Commercial Planned Development (CPD) Amendment to expand the existing CPD, formerly known as Big John's Board Walk Eatery, which was approved per Resolution No. 06-30.

RESOLUTION OF THE TOWN COUNCIL OF
THE TOWN OF FORT MYERS BEACH, FLORIDA
RESOLUTION NUMBER 12-07
EAGLE EQUITY CAPITAL CPD

EAGLE EQUITY CAPITAL LLC
 MASTER CONCEPT PLAN
 FORT MYERS BEACH, FLORIDA

TYPE OF CASE: Commercial Planned Development (CPD)
CASE NUMBER: FMBDCI2012-0001
LPA HEARING DATE: April 10, 2012
LPA HEARING TIME: 9:00 AM

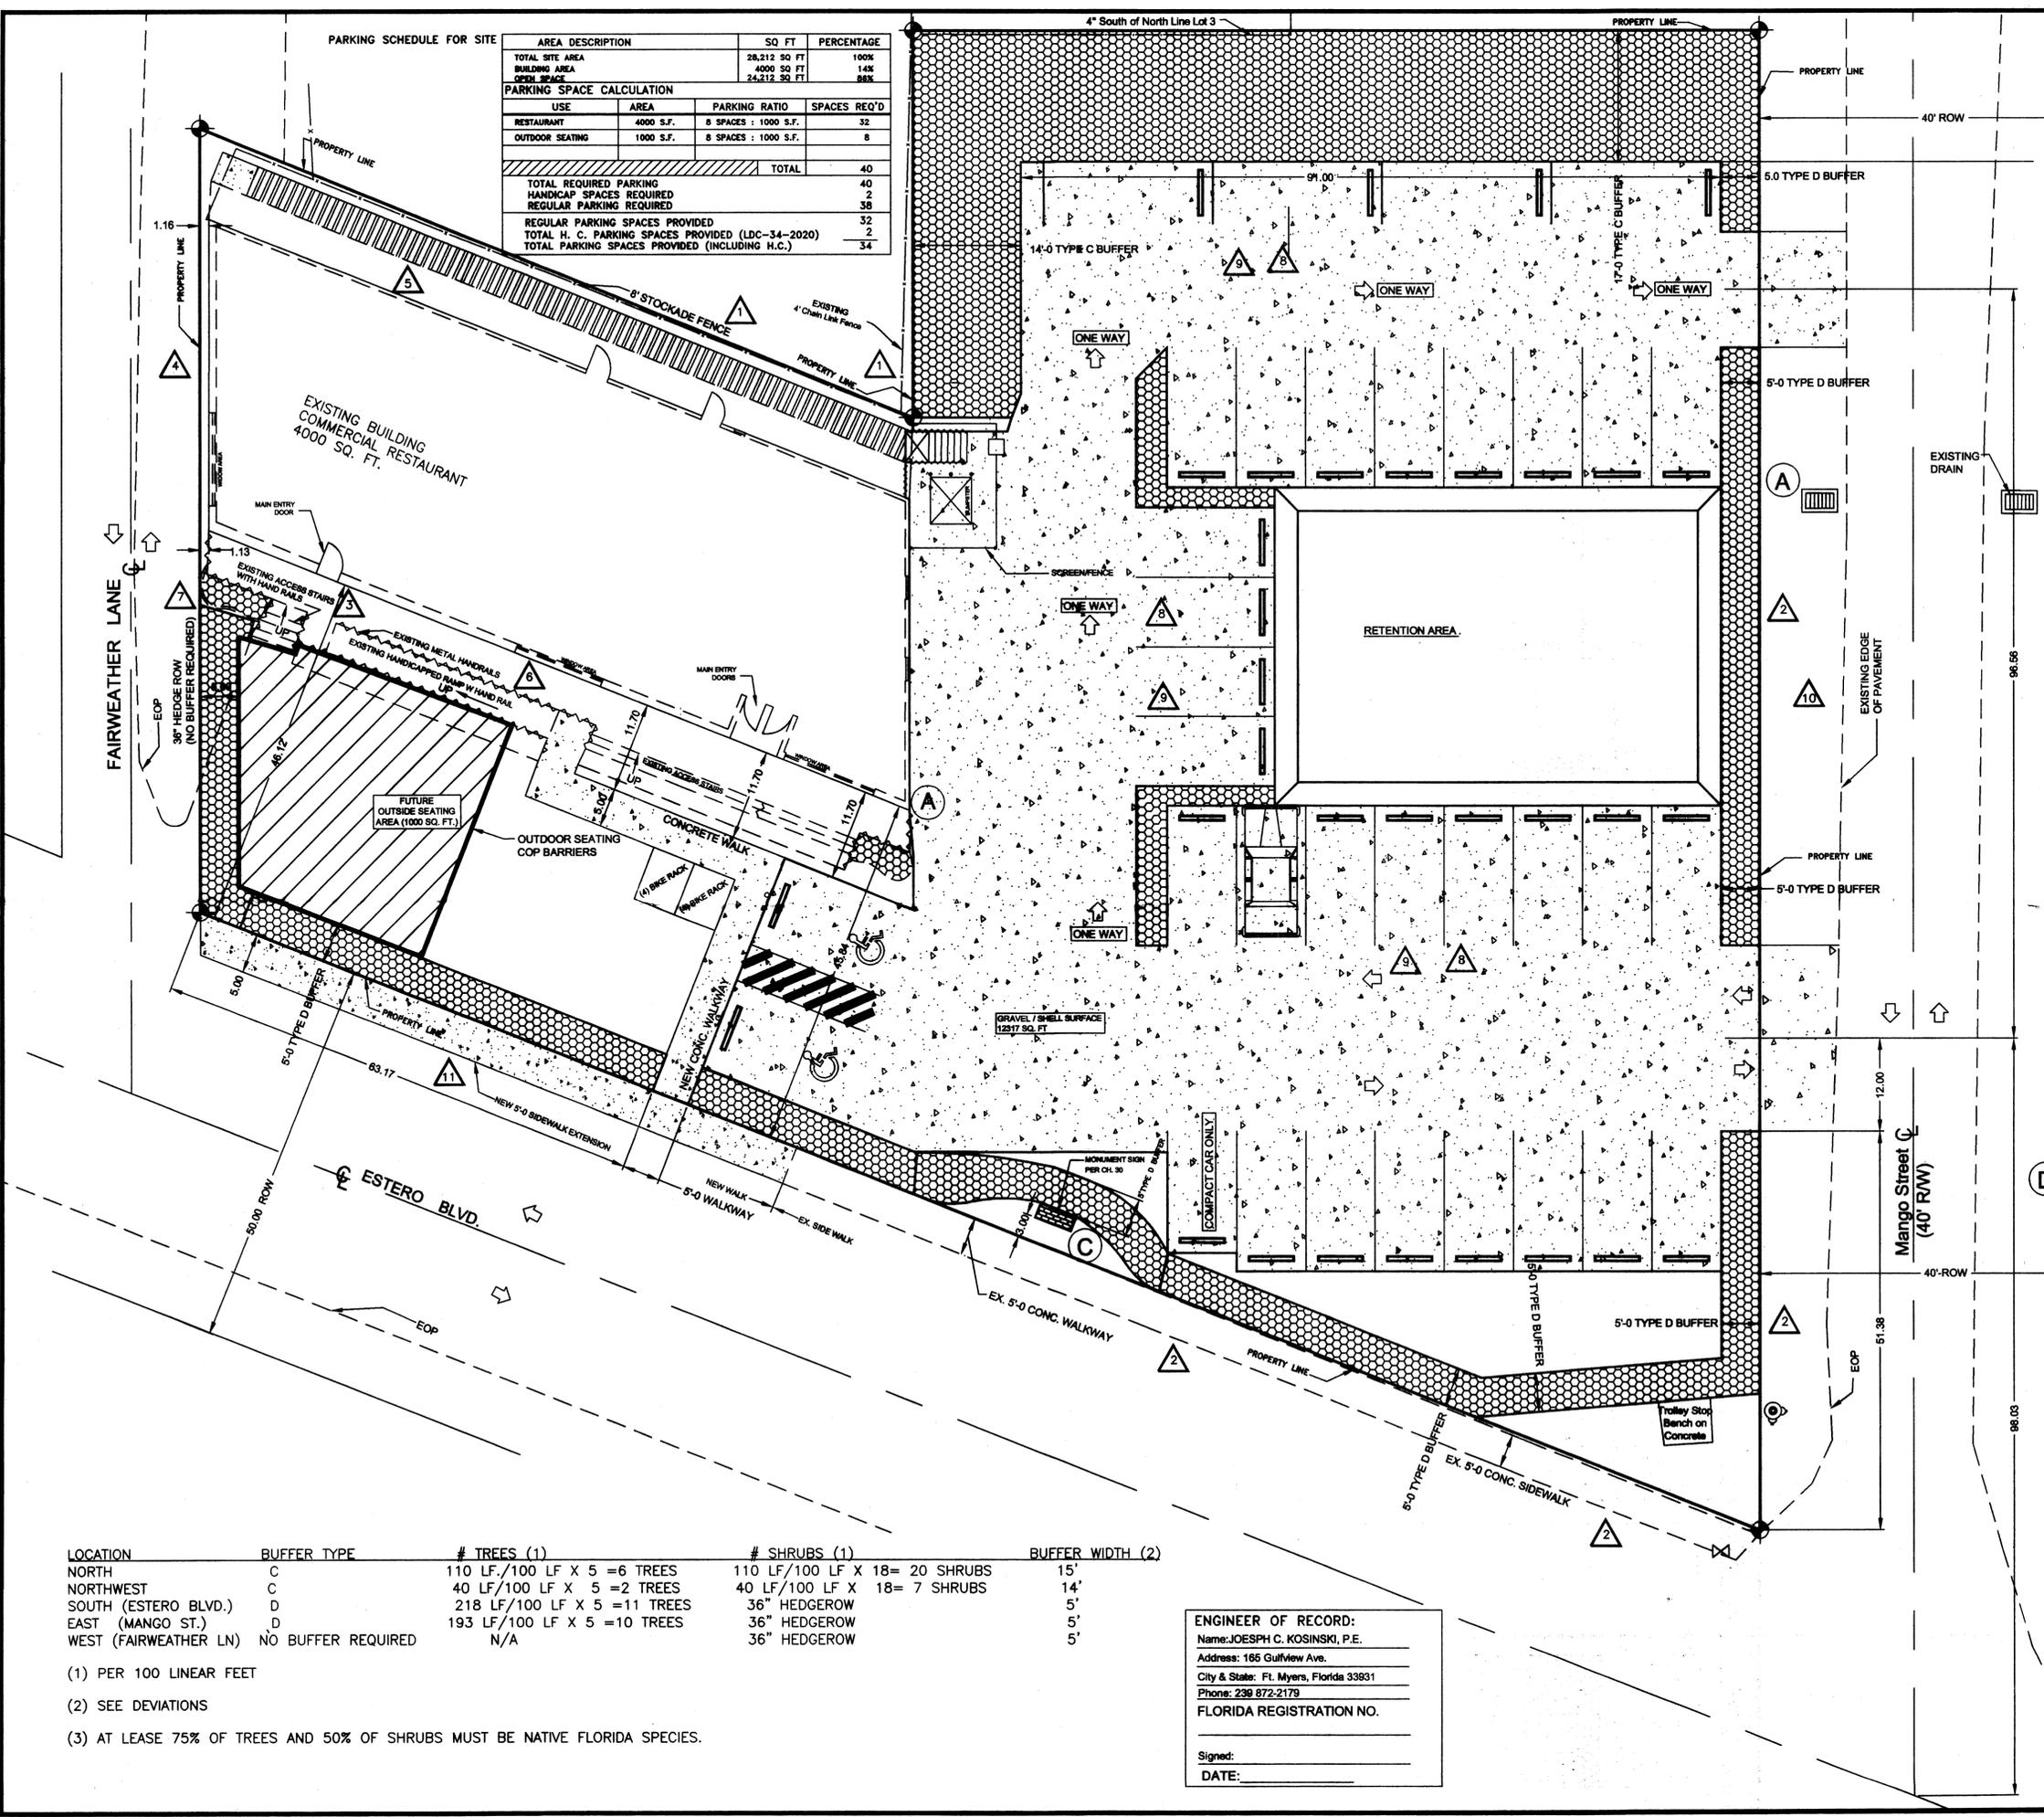
NOTE: Applicant's revised MCP submitted after the LPA meeting on 4/25/12 has satisfied this condition.

- c. Require the applicant to provide an easement for a future trolley shelter for the triangular shaped area labeled on the Master Concept Plan as “Trolley Stop Bench on Concrete” as a means of mitigating the requested parking reduction deviation.

Exhibit B – Illustrative Landscape Plan

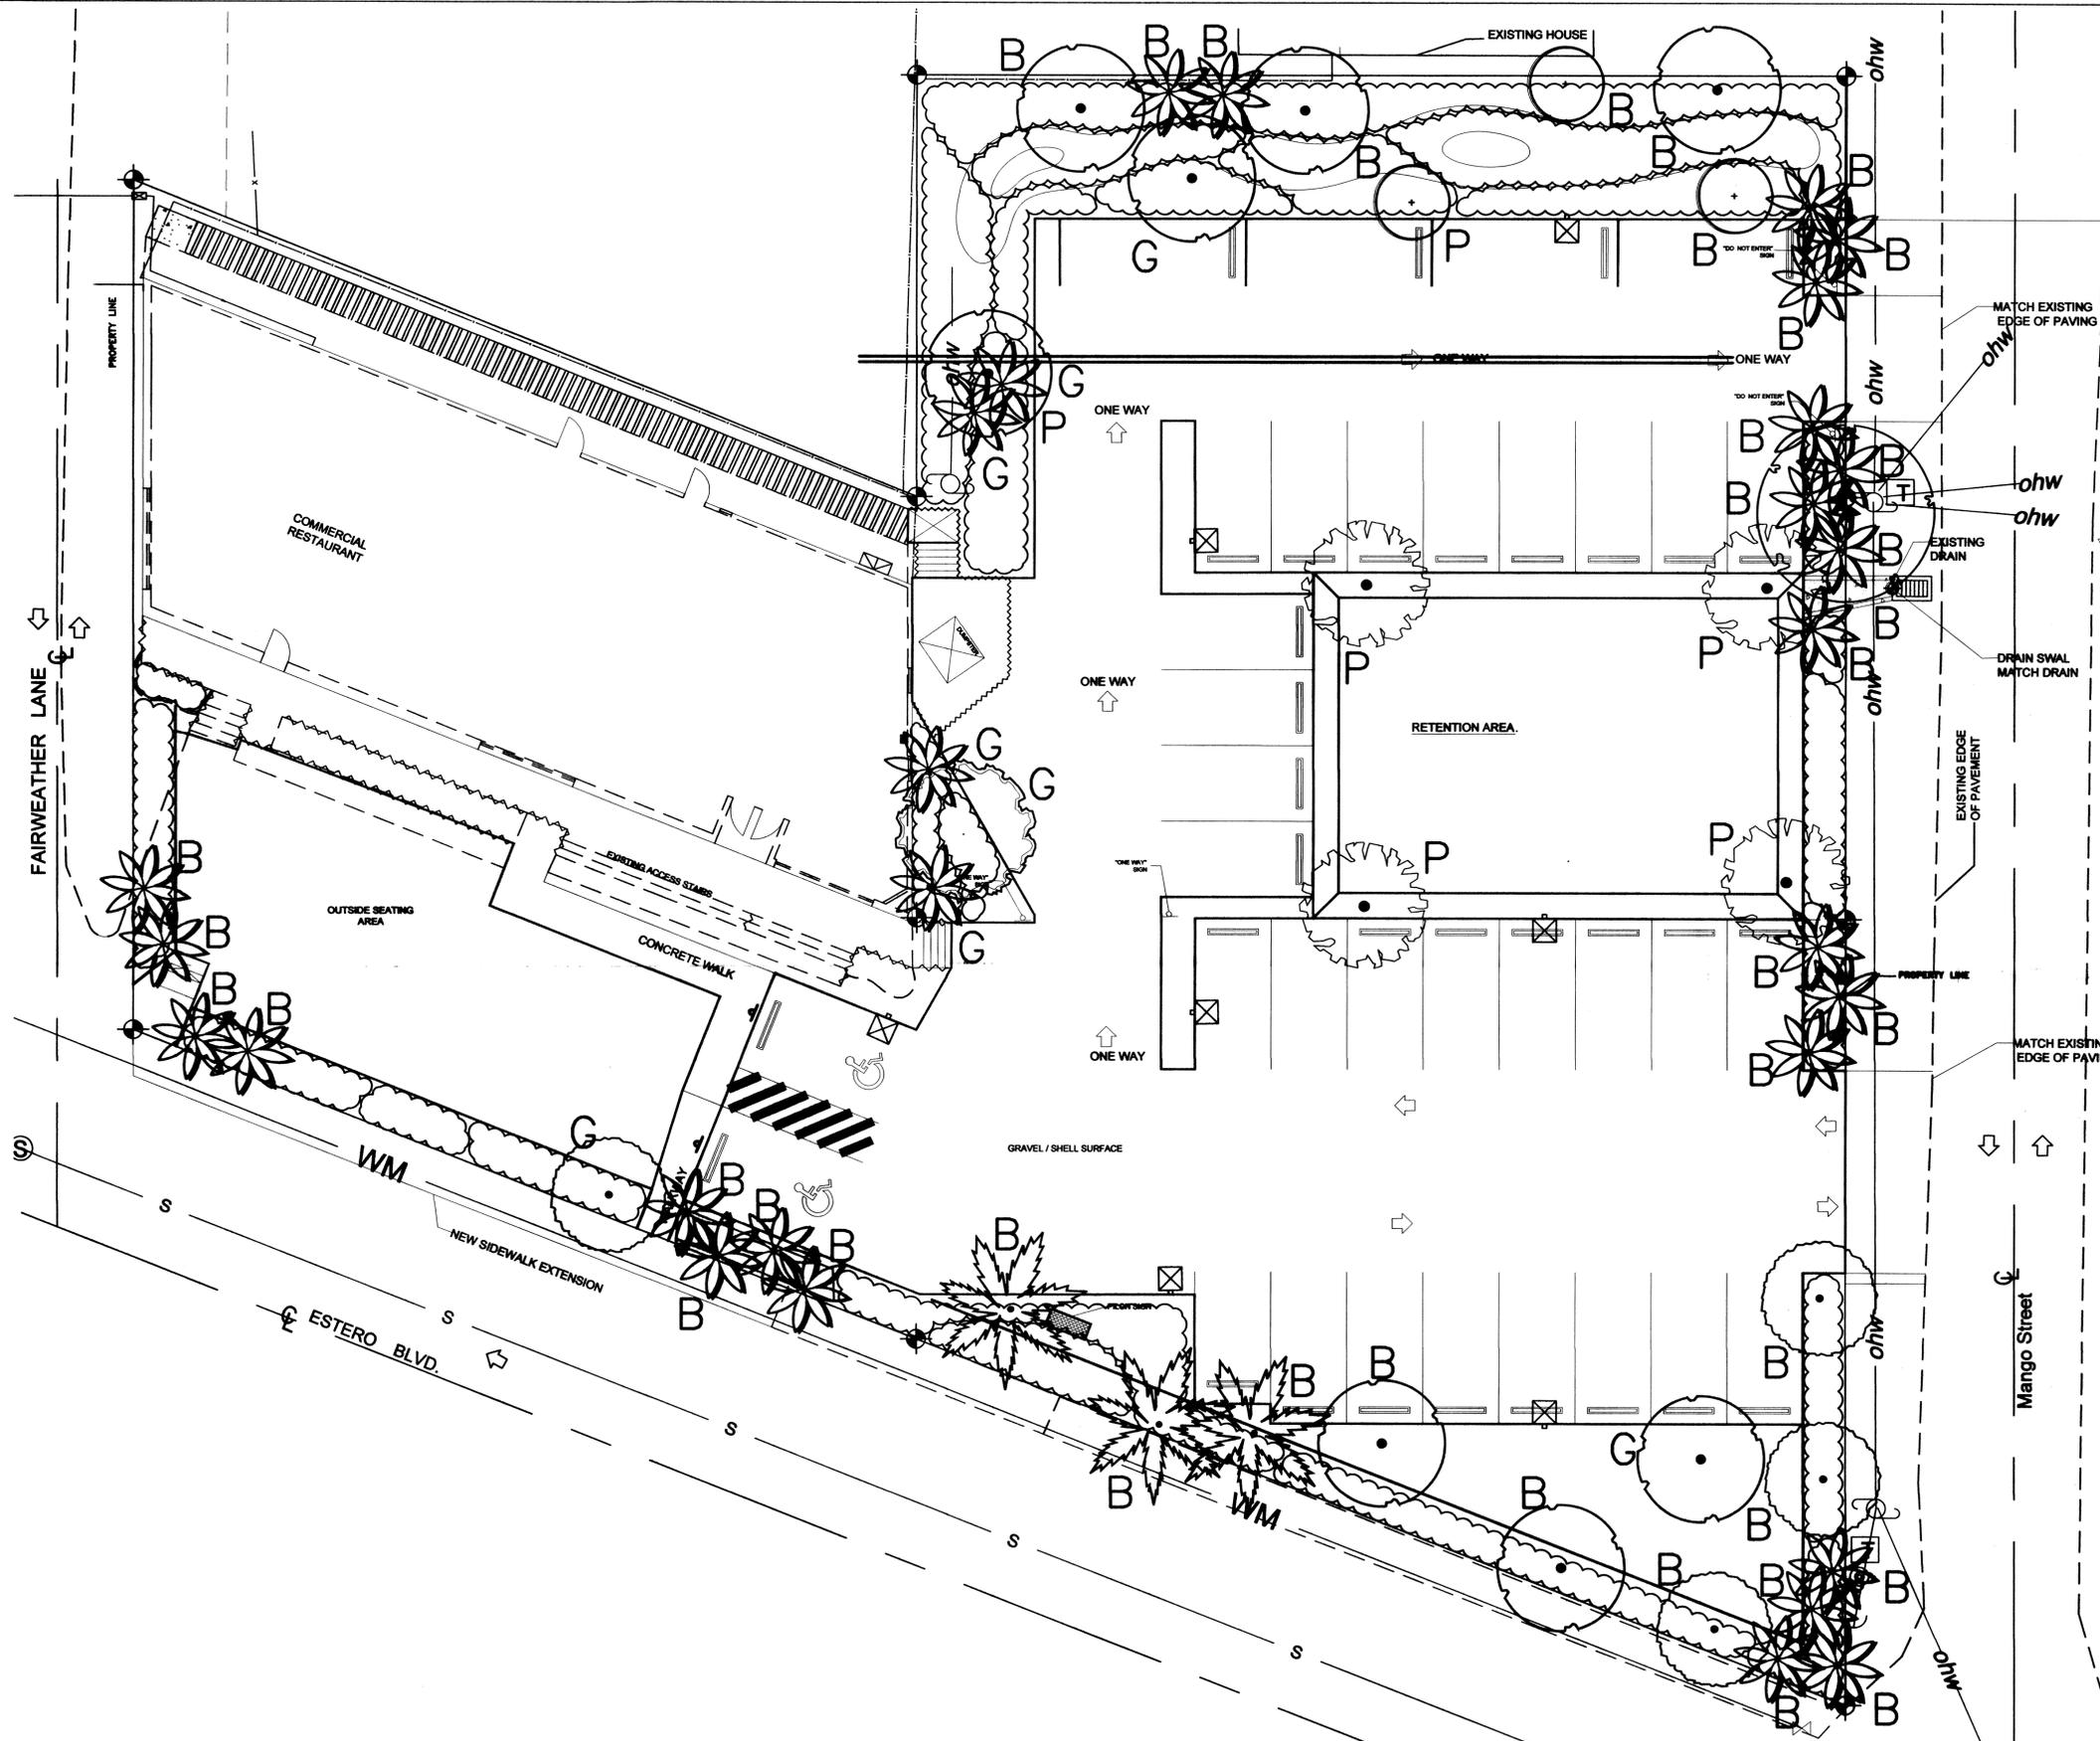
Staff recommends APPROVAL of the requested deviation. The 8 foot tall stockade fence was a condition of approval in Resolution 06-30 in order to provide screening between the existing building and the adjacent residential property to the north. The 2 foot rear yard of the 2301 Estero parcel limits the amount of buffering that can be provided, thus only the fence is feasible. The proposed Type C buffer along the western and northern property lines of the 121 Mango Street parcel will provide a visual screen between the residential uses to the north and the commercial uses on the subject property where currently there is no buffer. Staff is feels that the

Staff recommends APPROVAL of Deviation #2, because the request has no detrimental impact on the public interest and enhances the objective of the proposed planned development. Approving a reduction in required buffer widths is a mutually beneficial compromise as it allows for the most efficient use of the subject property and requires an aesthetic improvement to the Estero Boulevard and Mango Street road frontages. It should be noted that approval of this deviation does not include a reduction in required plant material; 5 trees per 100 linear feet and a double row hedge maintained at 36" will still be required along the Estero Boulevard and Mango Street frontages. Please see Exhibit B, for an illustrative landscape plan.
